**CC1021 Errata Note 001, rev. 1.0**

**CC1021 Errata Note 002, rev. 1.0**

Figure 1: Recommended PLL calibration procedure

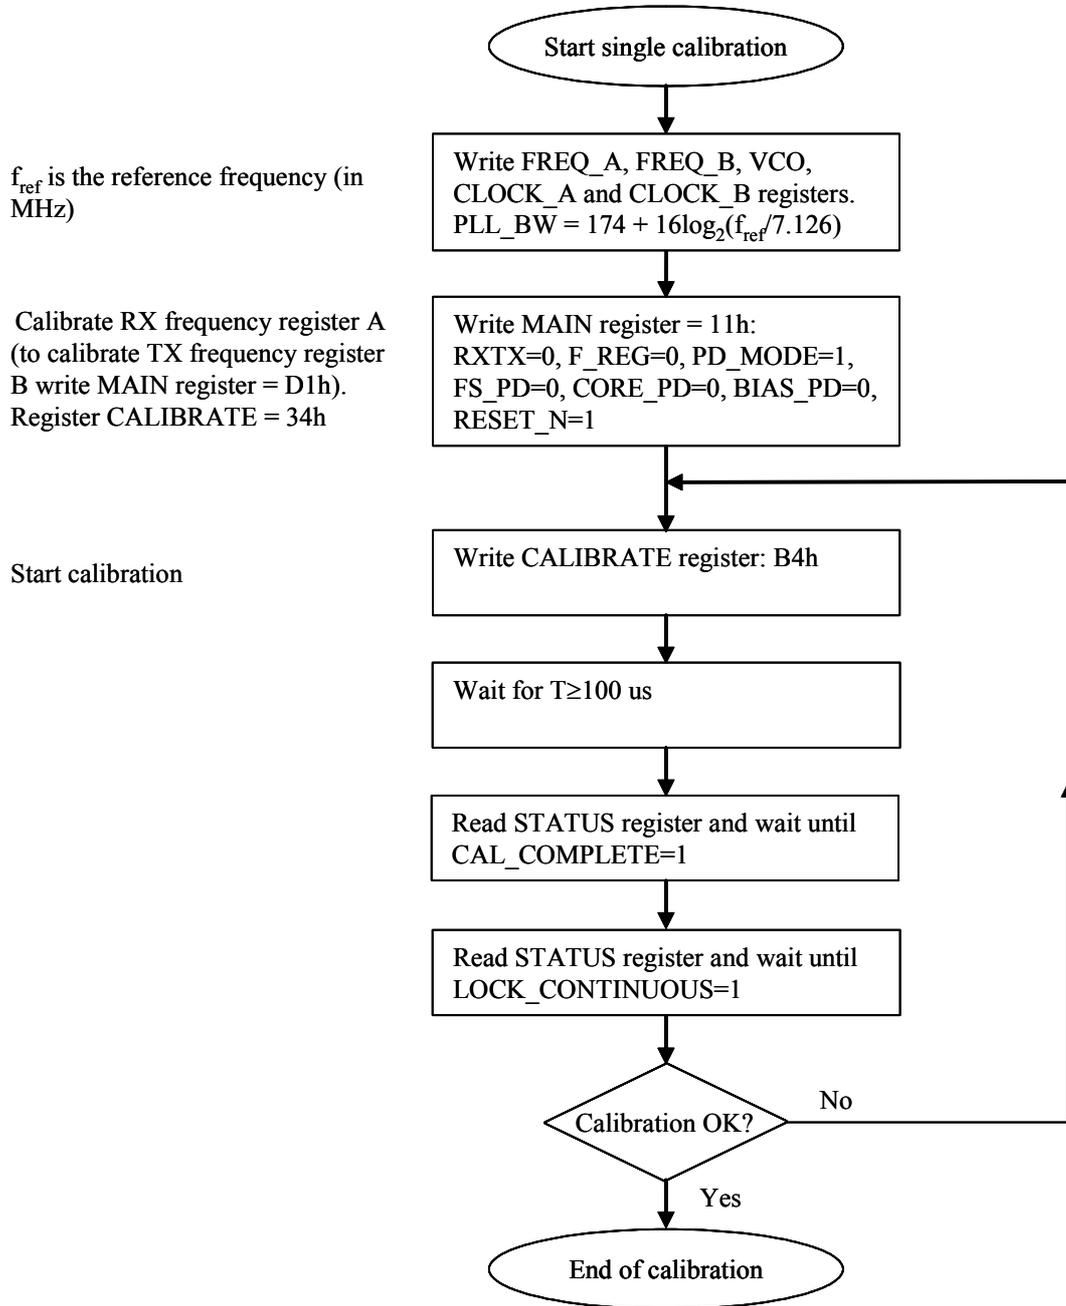
When using a 14.7456 MHz crystal frequency the CC1021 calibration (monitored by steps 2 and 3) typically lasts 27 ms. However, it has been observed that the CAL\_COMPLETE indicator in the STATUS register is unreliable during the first 100  $\mu$ s after initiating the calibration. As a result step 2 might indicate calibration complete too early, i.e. before the actual calibration has actually completed. In such a situation step 3 (LOCK monitoring) is executed during instead of after calibration. In order to avoid this inconsistency, a waiting period of at least 100  $\mu$ s between calibration start and the start of the polling should be applied using one of the following methods:

In less than 10 ppm of all PLL calibrations performed it was observed that CC1021 did not achieve LOCK even when introducing a 100  $\mu$ s wait period before polling of [STATUS.CAL\_COMPLETE] was initiated. The reason for no LOCK still occurring, even when calibrating the PLL with this small wait period, is due to the PLL calibration procedure making an erroneous frequency measurement causing the PLL calibration algorithm to choose a wrong capacitor array setting producing a no LOCK situation. For this reason it is important to control that the PLL calibration achieves LOCK and recalibrate if it does not.

Calibration starts when CALIBRATE.CAL\_START is set to 1 as shown in figure 1. The PLL is then set to open loop and the internal VCO control voltage set to a value given by CALIBRATE.CAL\_ITERATE[2:0] = 4<sub>n</sub>. Based on this value a capacitor array is selected and when the calibration is completed the PLL loop is closed.

For those users who have not already implemented a recalibration procedure in software it is strongly recommended to avoid polling [STATUS.CAL\_COMPLETE] until 100  $\mu$ s has elapsed following calibration start, then monitor LOCK after calibration complete and, if LOCK is not achieved, recalibrate until LOCK is successfully achieved. The recommended calibration procedure, including recalibration, is provided in figure 1.
